Regarding Issuance of Development Permit No. DP-428 (Uptown Ridge)

We have a few concerns and unanswered questions about the next phase of development known as Uptown Ridge. At the time we purchased unit 24 at Uptown Village construction of our phase had not yet begun. We relied solely on the Uptown Village website for floor plans, exterior views and a detailed landscape plan from landscape architect Eric Reynard. In particular the landscape plan that the end unit 24 would be surrounded by substantial vegetation and there would be a planted buffer from the proposed, future multi storey condominium building in the next phase known as Uptown Ridge. The plan for Uptown Ridge has since been changed to include four triplex buildings.

Original Landscape Plan

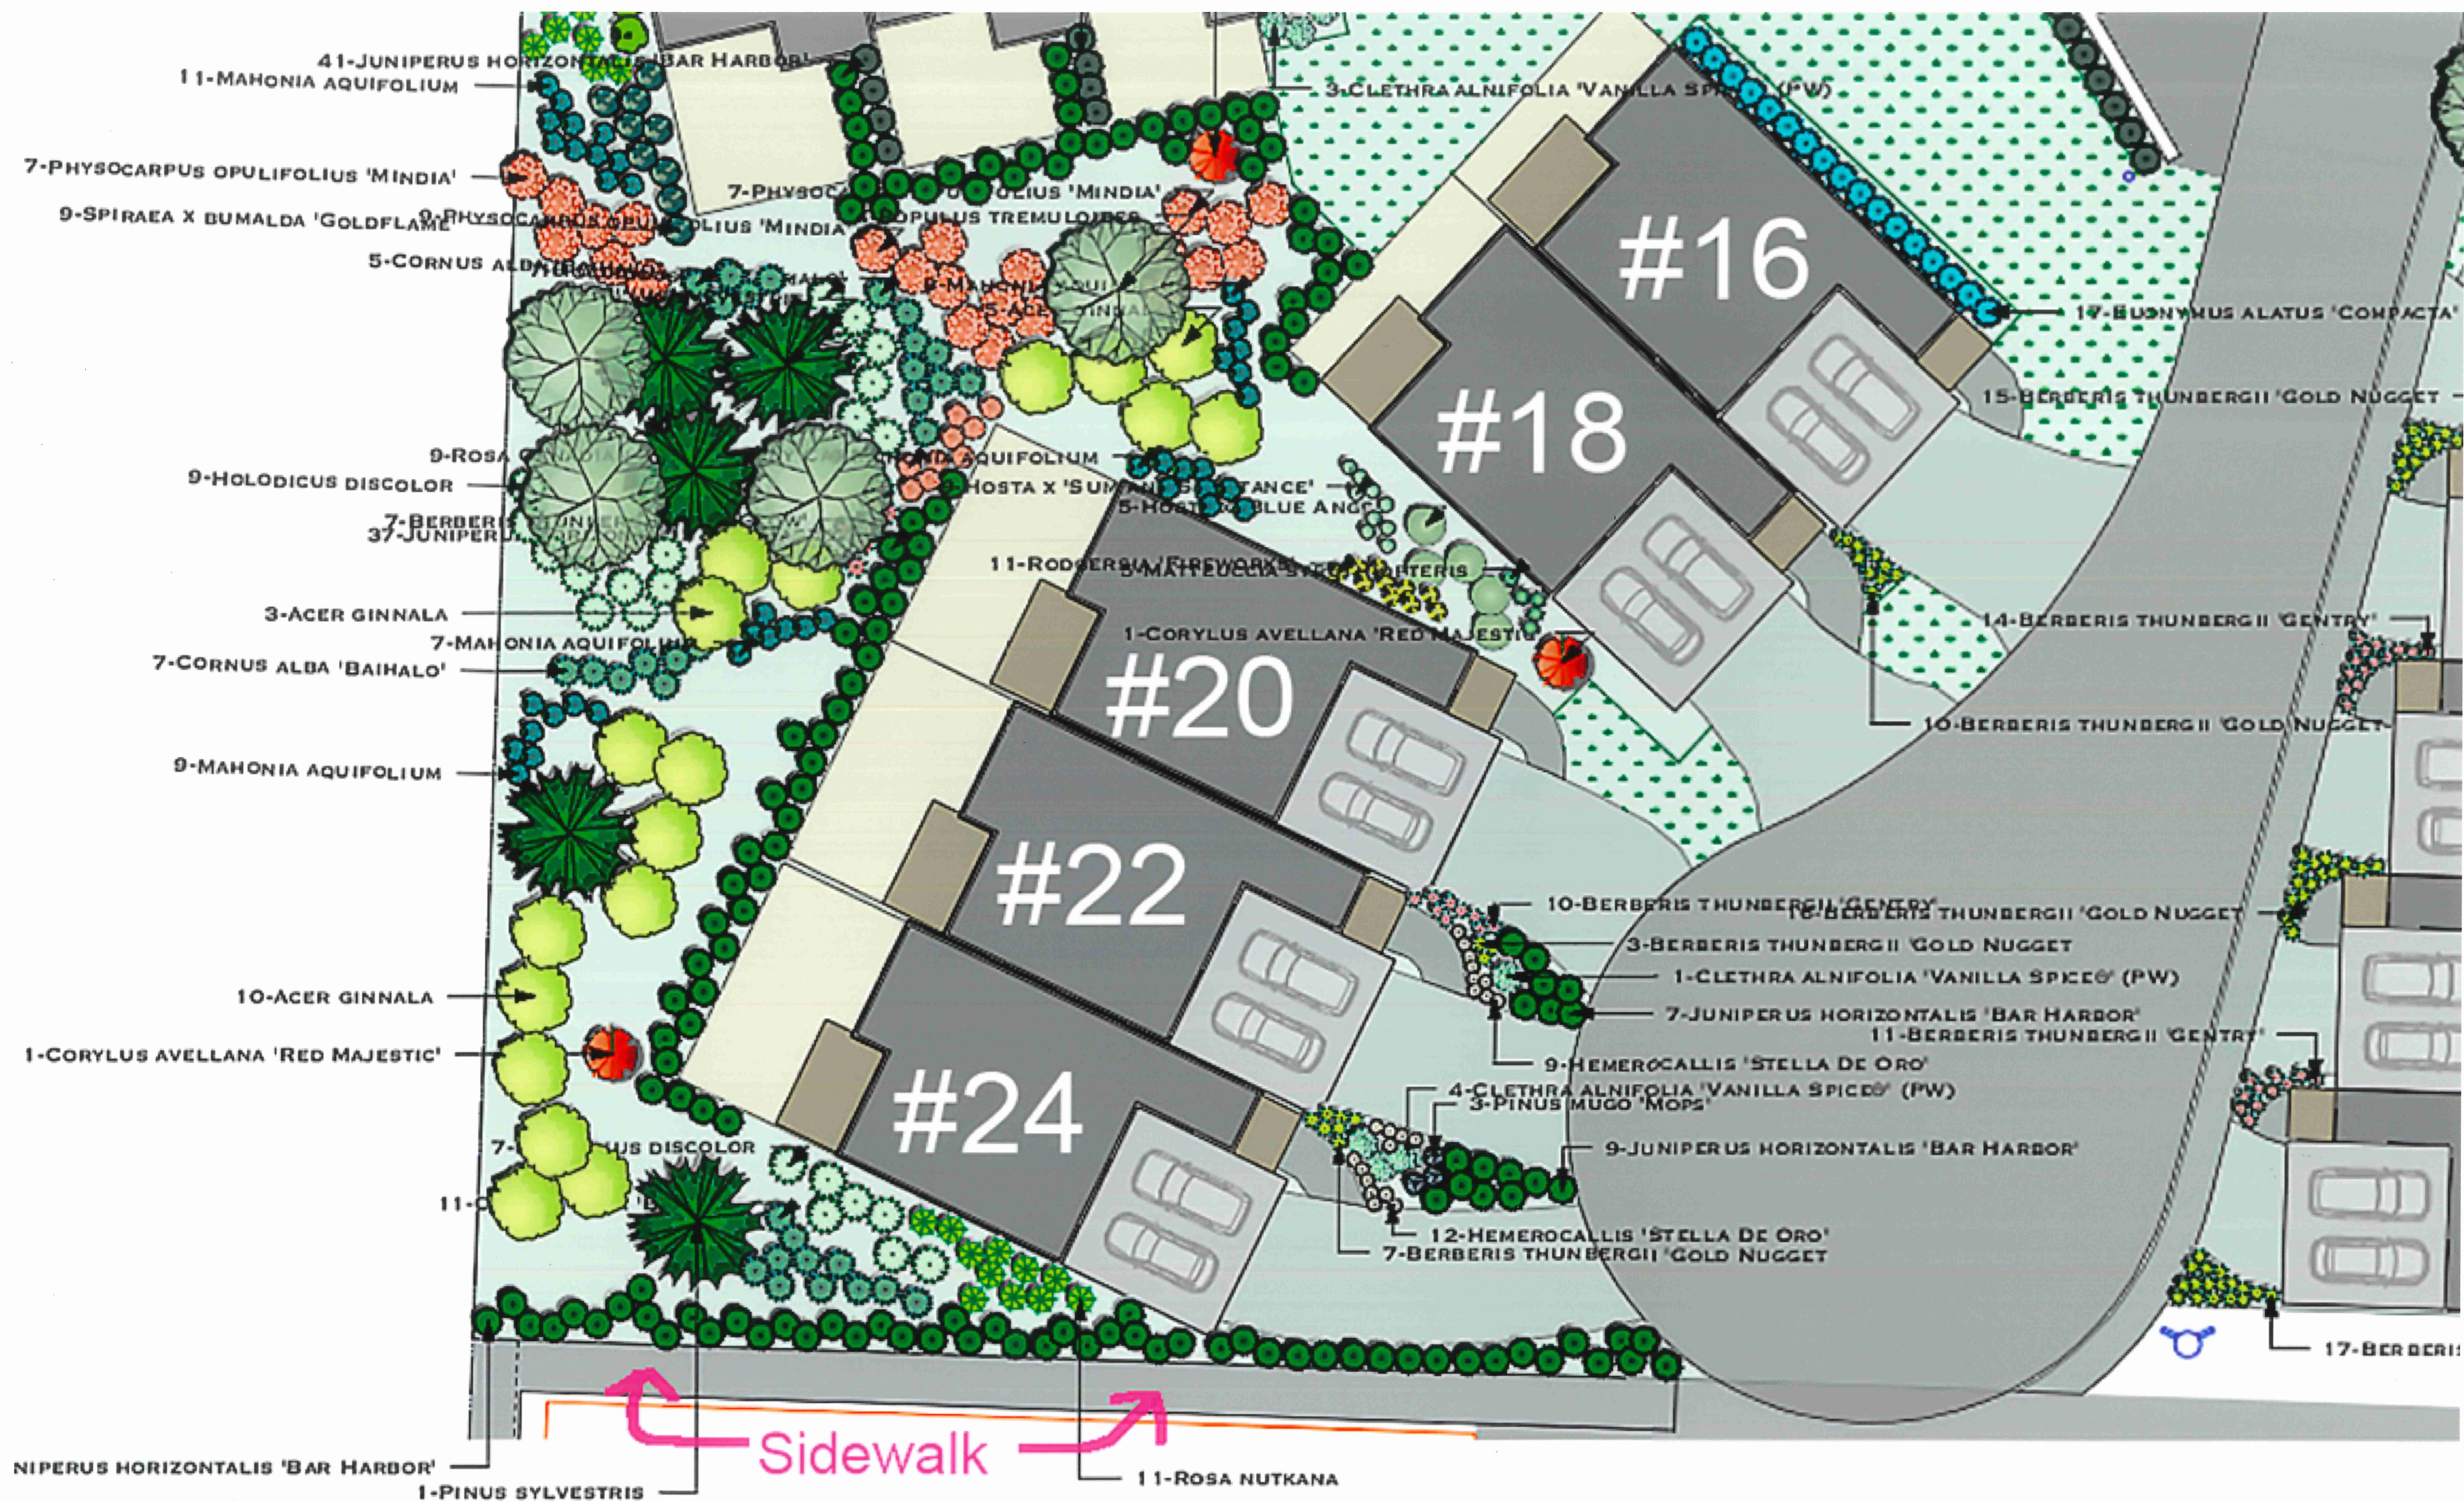
We are asking to have The new sidewalk either moved back to the original location as detailed in Eric Reynard's original landscape plan or to be removed completely and have the trail through the forest connect with the paved roadway that will be built to service units seven to twelve. The tiny plot of land between townhouse 24 of Uptown Village and the above mentioned paved roadway should be 'heavily' planted as indicated on the original landscape plan to create a visually pleasing space that would create a privacy and a visible barrier for unit 24.

We moved into unit 24 of Uptown Village in October 2020 and to say we are disappointed in the landscaping would be an understatement. Plantings are minimal and bare no resemblance to the landscape architects original plan. Sadly we look out onto a rock pile with a scattering of small plants that are barely noticeable. Why was the landscape plan that was also required to be submitted to the City of Salmon Arm planning department ignored by all involved?

See Drawing A01

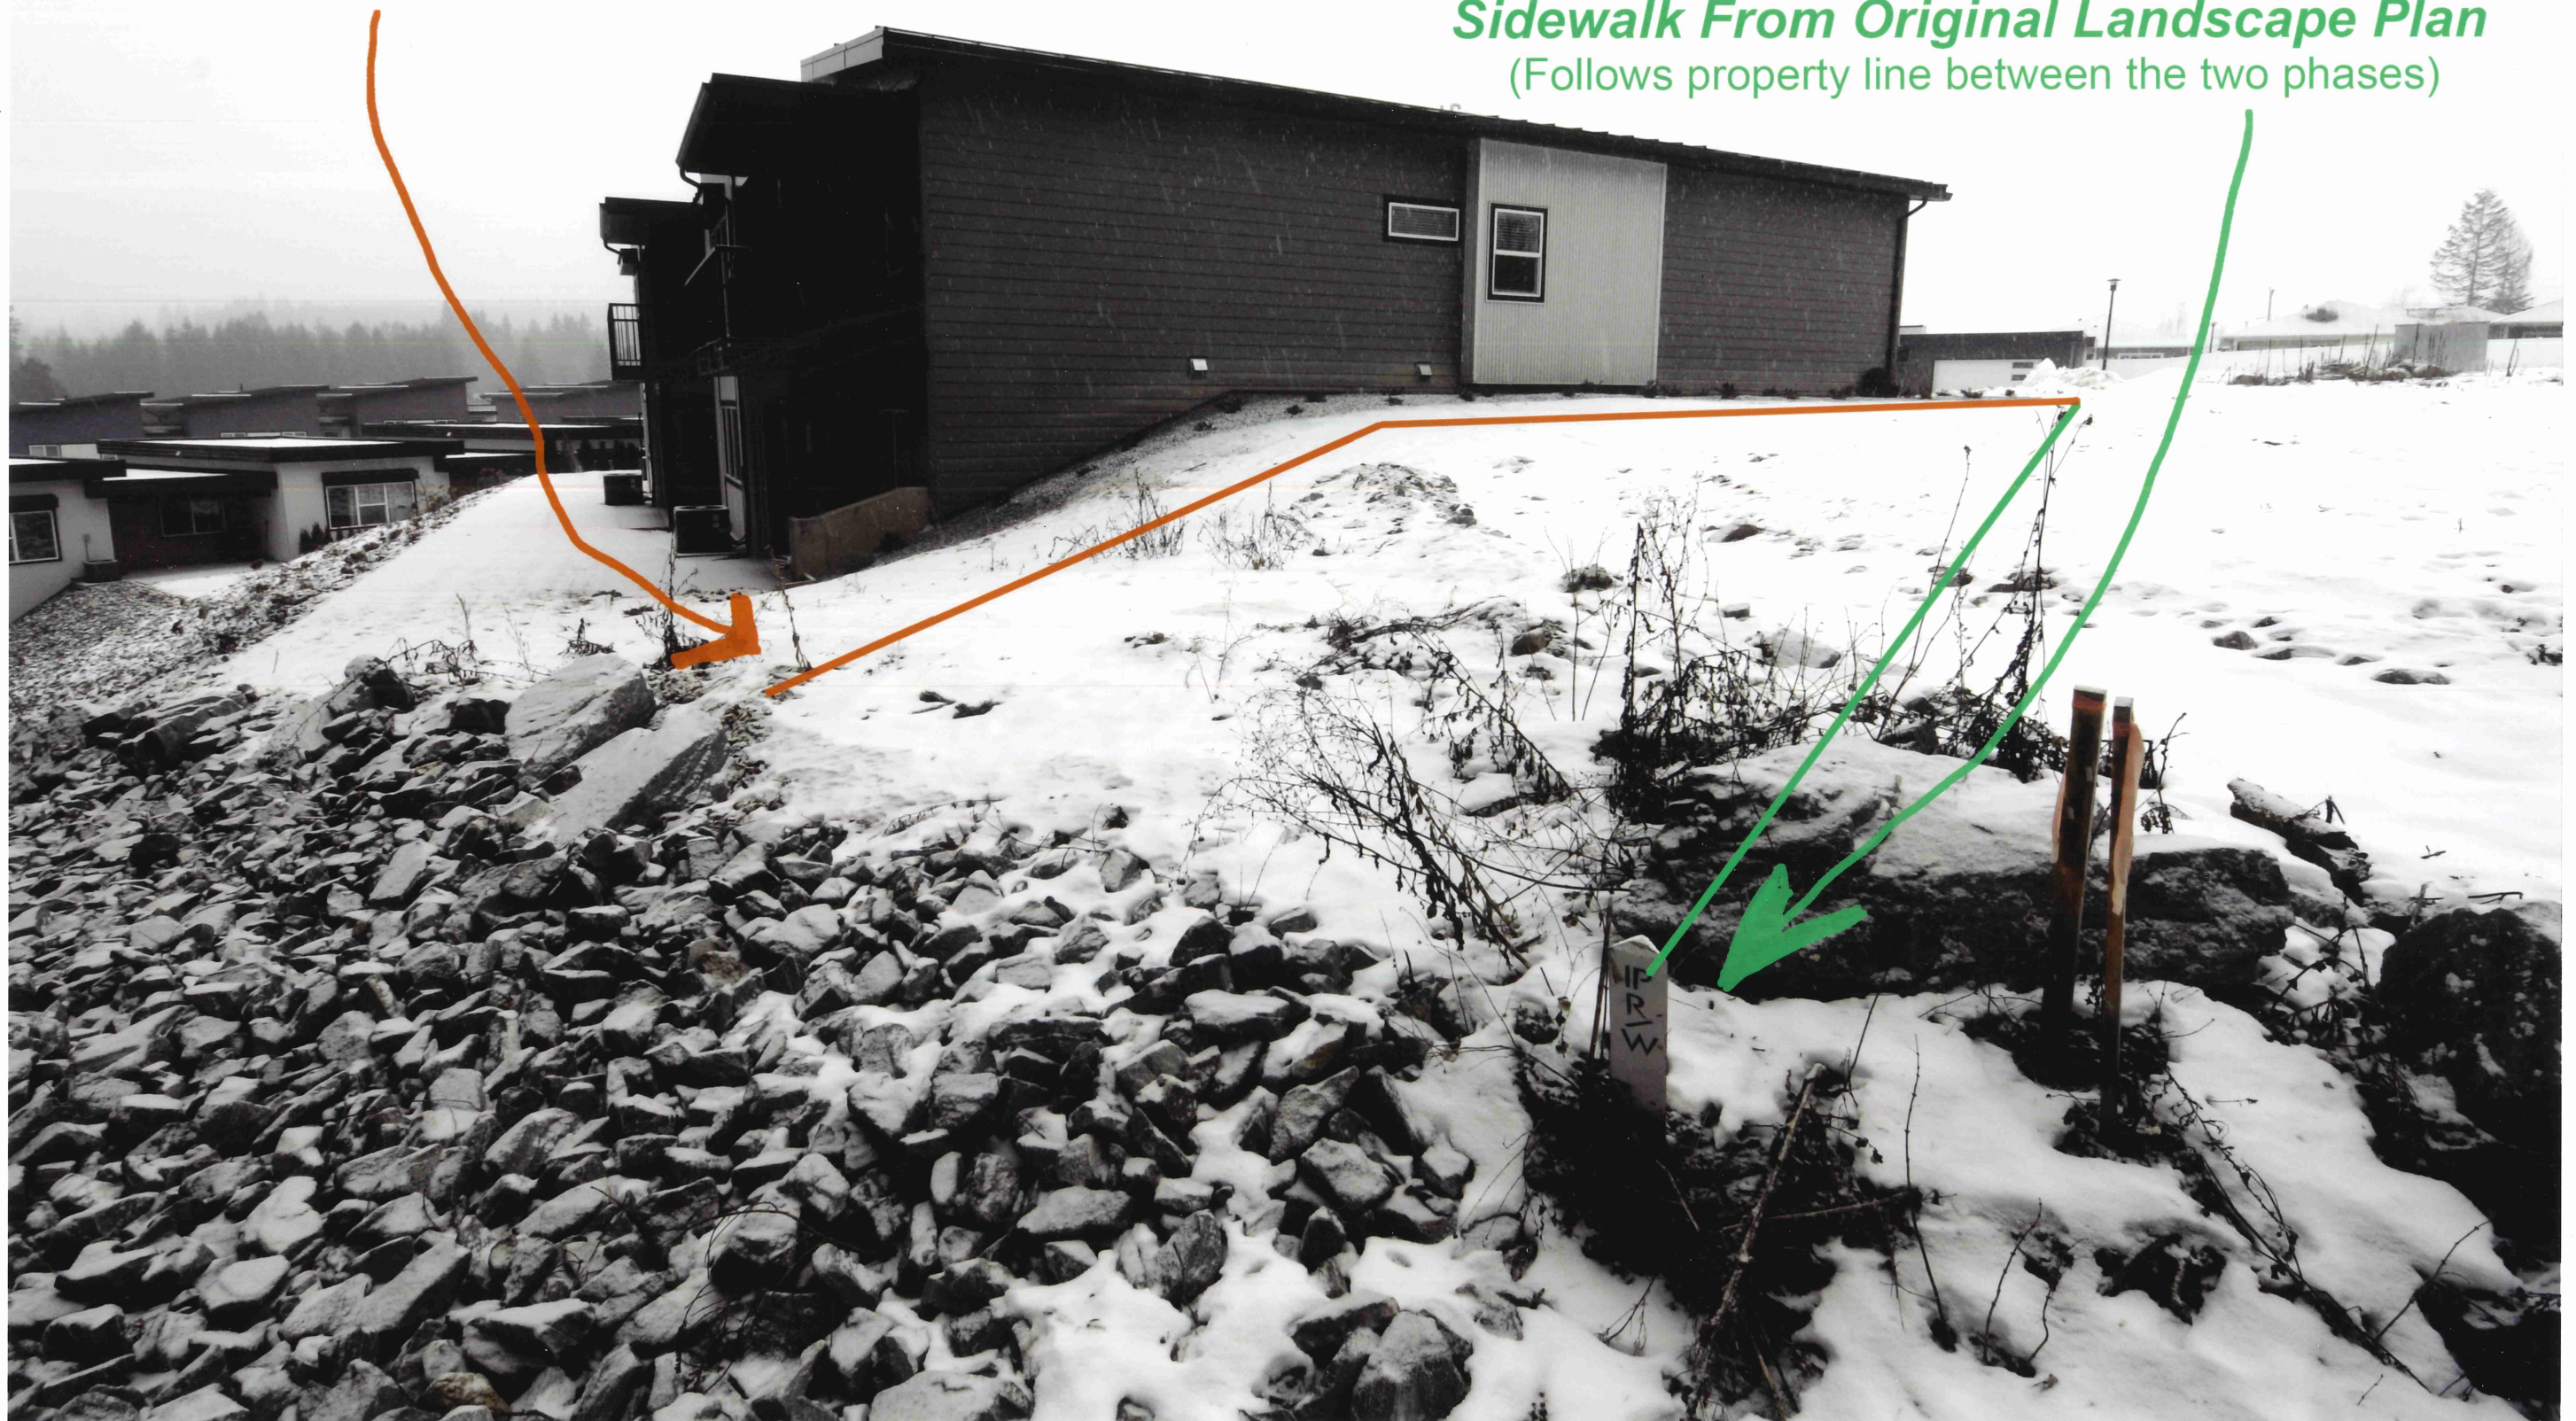
If the new sidewalk is installed as close to our townhouse as indicated on the new plan (***Drawing A01***) it will pass within a few feet of a bedroom window. At eye level! How would you like to live with that?

Sidewalk From New Uptown Ridge Site Plan
(Parallels Unit #24 about five feet from the edge of the unit)

Sidewalk From Original Landscape Plan
(Follows property line between the two phases)
